Access Compliance Report

Public Rights-of-Way

Intersection ID: 30037	Main Street: MORNING_CREEK_LN	Cross Street: TWIN_ASH_CT	Location:	E
ADA ID: 39D33B9517ED	Ramp Type: BlendTrans1	Initial Pass/Fail: Fail	Overall Compliance: No	Severity Score: 10

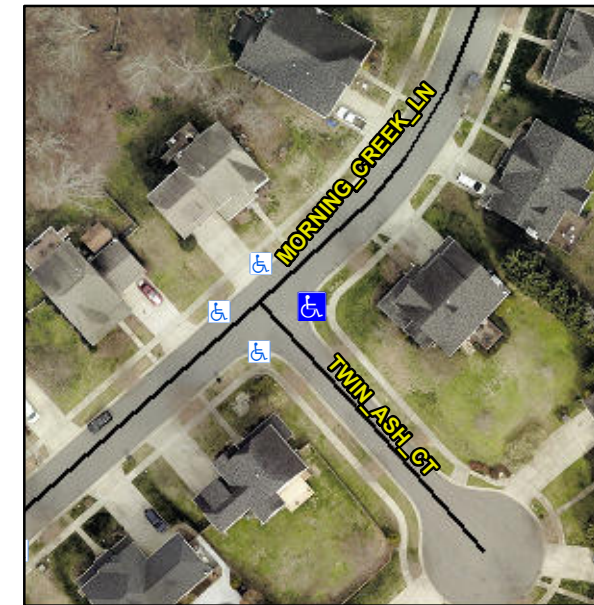
Not Found, R304.5.1, R304.5.3

Compliance	Description	Data	Compliance	Description	Data
N/A	Ramp Length (in)	37.0	Yes	BlendTrans Slope (%)	3.5
No	Ramp Width (in)	47.0	No	BlendTrans XSlope (%)	3.1
N/A	Flare Type LT	N/A	N/A	Flare Type RT	N/A
N/A	Flare Slope LT (%)	N/A	N/A	Flare Slope RT (%)	N/A
N/A	Flare Traversable LT?	N/A	N/A	Flare Traversable RT?	N/A
N/A	Landing Length (in)	N/A	N/A	DWS Provided?	N/A
N/A	Landing Width (in)	N/A	N/A	DWS Contrast?	N/A
N/A	Landing Slope (%)	N/A	N/A	DWS Length (in)	N/A
N/A	Landing X Slope (%)	N/A	N/A	DWS Full Width?	N/A
N/A	Landing Curb? (Y/N)	N/A	N/A	DWS Offset (in)	N/A
N/A	Shared Landing?	N/A			
N/A	Gutter Ponding?	N/A	N/A	Gutter Slope (%)	N/A
N/A	Gutter Lip Ht (in)	N/A	N/A	Gutter X Slope (%)	N/A
N/A	Painted X Walk1?	No	N/A	Painted X Walk2?	No
	X Walk 1 Direction	To NW		X Walk 2 Direction	To SW
	X Walk 1 Width (in)	N/A		X Walk 2 Width (in)	N/A
	X Walk 1 Slope (%)	0.1		X Walk 2 Slope (%)	2.9
	X Walk 1 X Slope (%)	1.0		X Walk 2 X Slope (%)	3.9

N/A	Ramp inside XWalk1?	N/A	N/A	Ramp inside XWalk2?	N/A
	Road Slope (%)	1.5		Clear Space?	N/A
	Road X Slope (%)	3.0	N/A	Clear Space to XWalk (in)	N/A
N/A	Any Obstructions?	N/A	N/A	Storm Grate/Utility Hazard?	N/A
	Obstruction Type			Storm Grate/Utility Type	
		N/A			N/A
			Yes	Surface Condition? (G/P)	Good
			No	Curb Slope (%)	15.0

Remove & Replace Curb Ramp With Two New Directional Ramps or Equivalent.
